## VOLTAGE CONVERSION 3.3V TO 1.05V

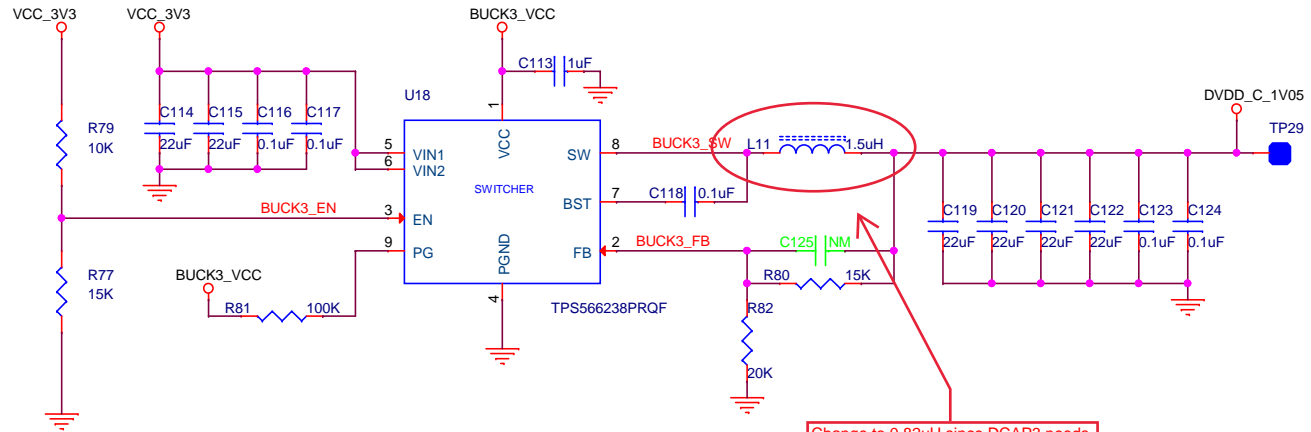
Change to 0.82uH since DCAP3 needs around 1.5A ripple current for stable system. Please refer to datasheet table 8-2. Remember your input is 3.3V, not 12V in table 8-2
